THE CITY OF SAN DIEGO TO THE PARK AND RECREATION BOARD

SUBJECT: North Ocean Beach Gateway – Approval of General Development Plan

Ocean Beach Gateway

General Development Plan

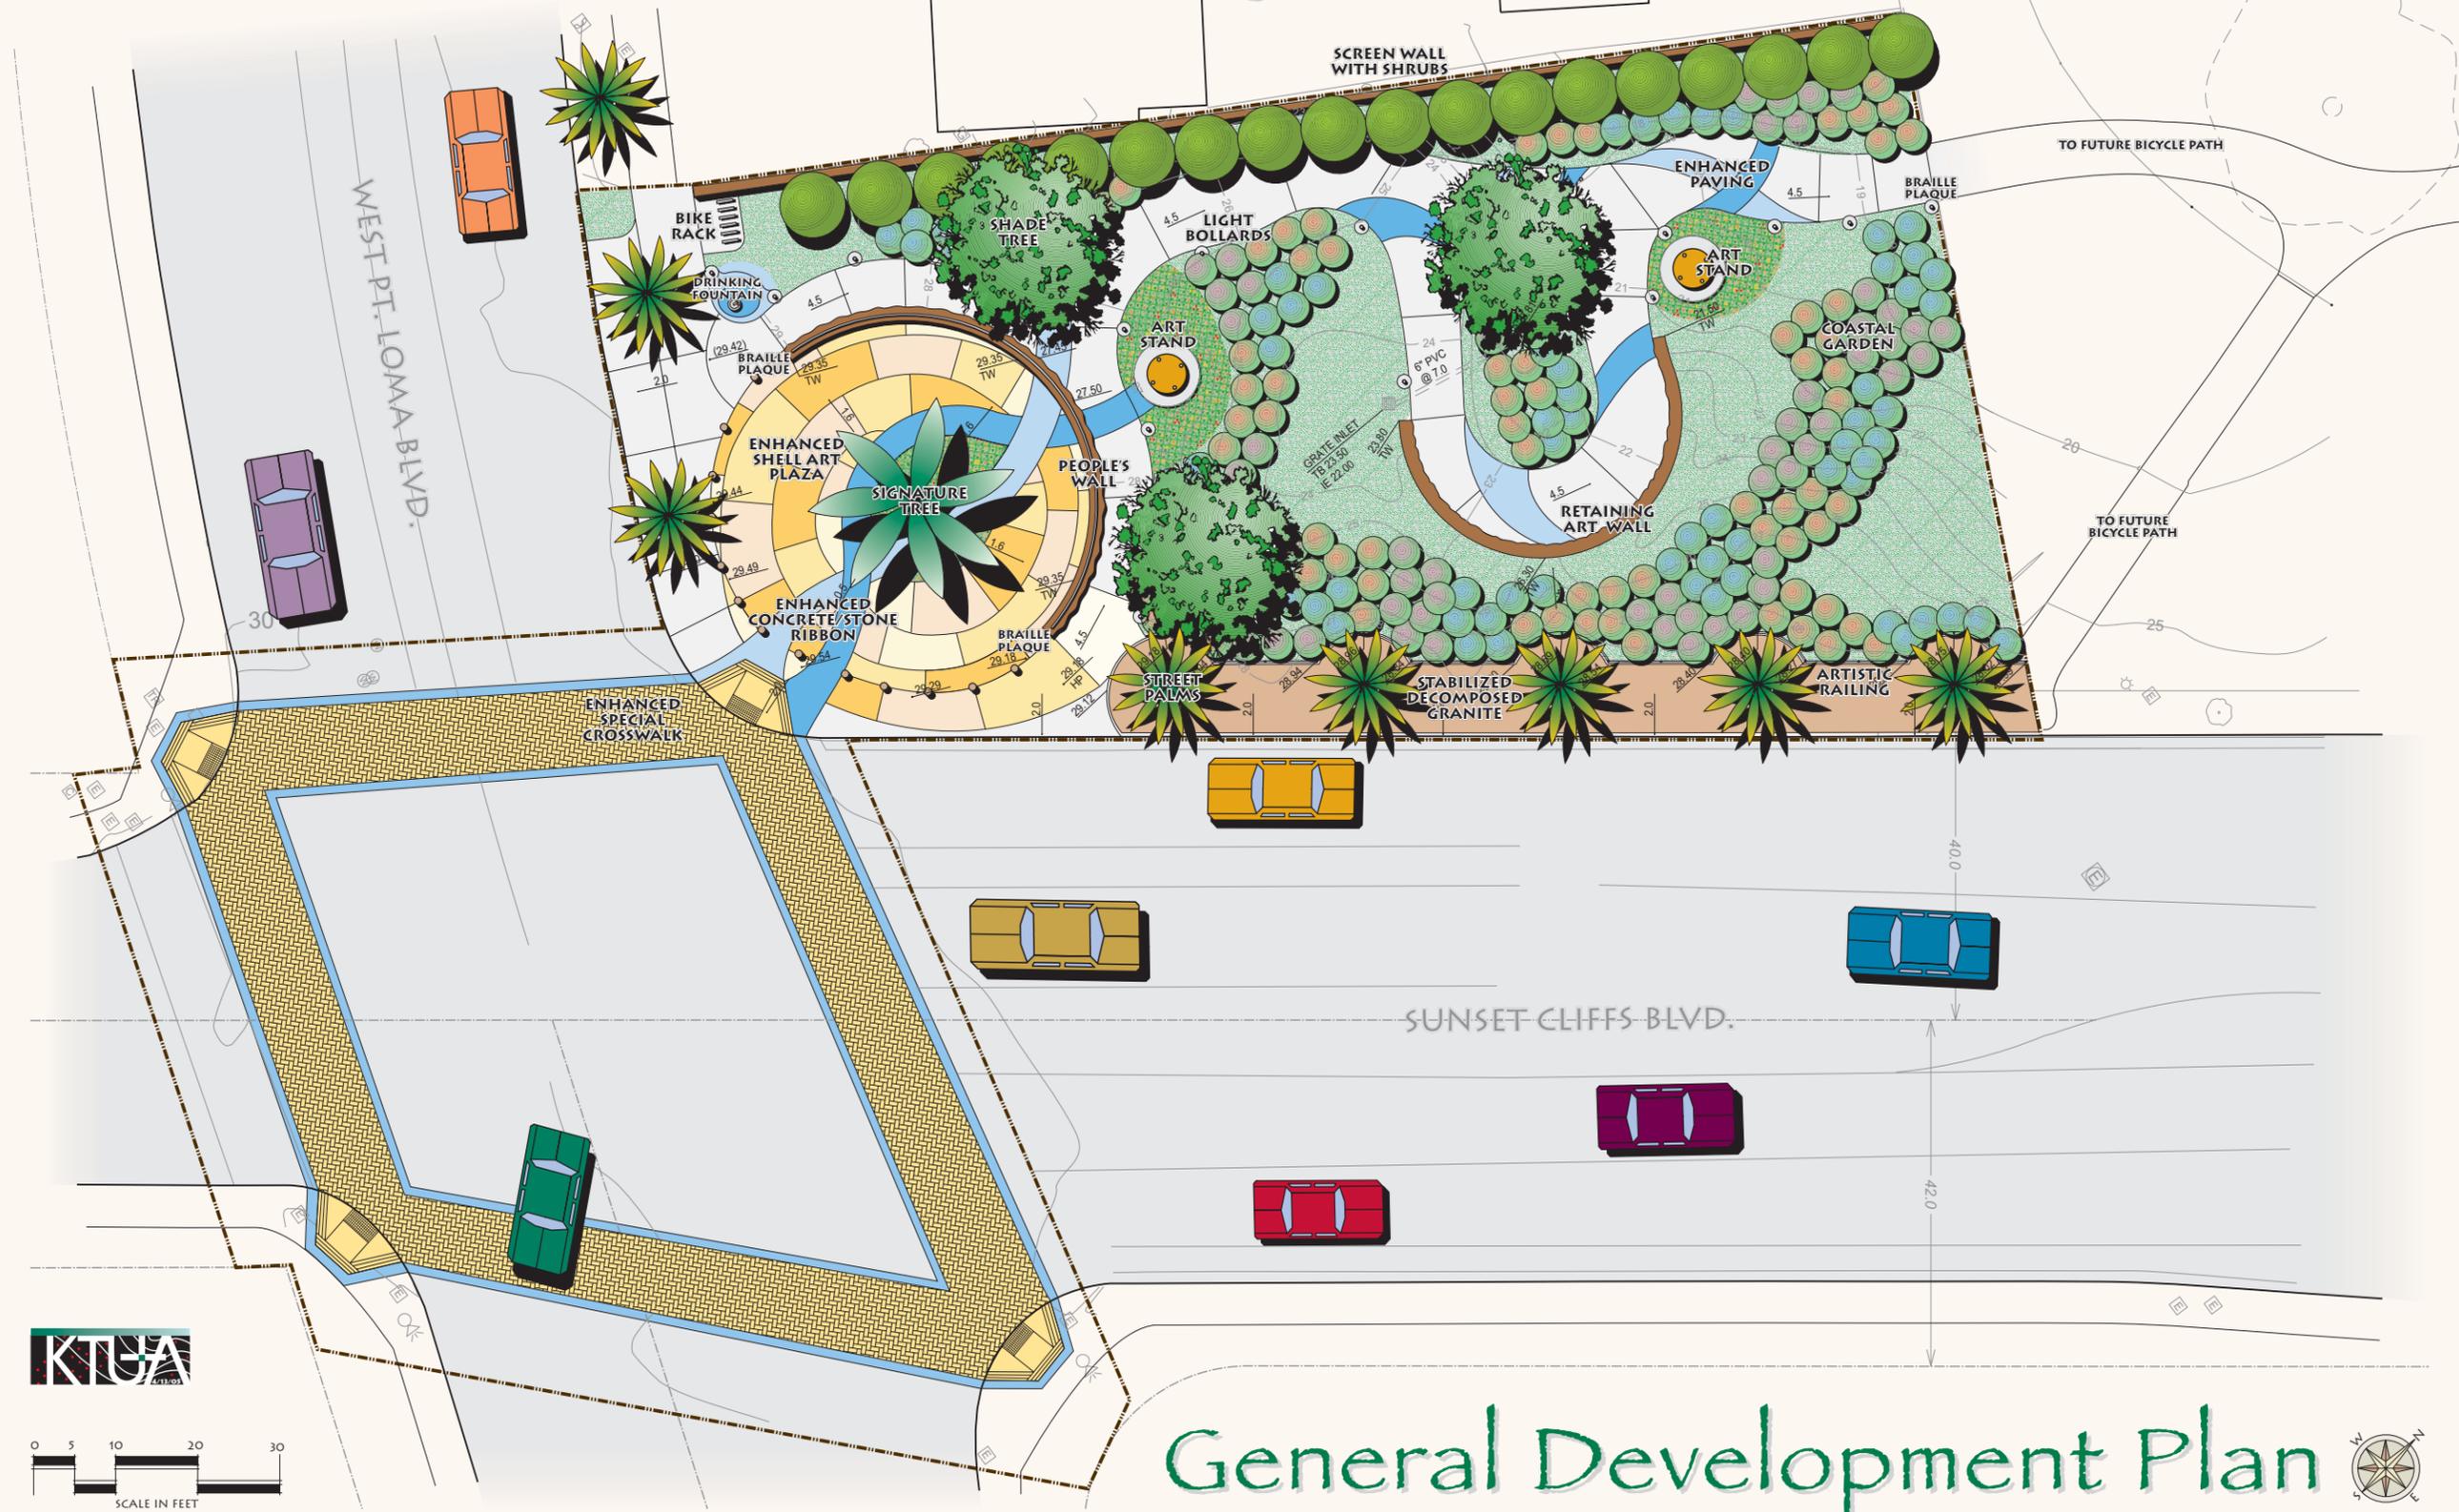
On September 22, 2004, the Ocean Beach Community Development Council (OBCDC) reviewed the GDP and recommended moving forward with the design with the following input from the community:

- Use native and/or drought tolerant plant where feasible
- Use low level walk lights
- Provide a drinking fountain

the proposed GDP with following recommendations:

- Provide an alternative specie for the “signature” palm.
- Review termination of the ends of railing and wall
- Review alignment of the palms along Point Loma Avenue
- Review locations of bollards and widths of path
- Relocate the existing palm along Point Loma Avenue to the location of the proposed palm to the west
- Align the end of the decomposed granite path with existing path to future bikeway
- Review location of the bike rack
- Consider adding a “dog bowl” component to the proposed drinking fountain

With the exception of the Design Review Committee’s first recommendation, all of the recommendations of the committees have been considered and incorporated into the proposed GDP.
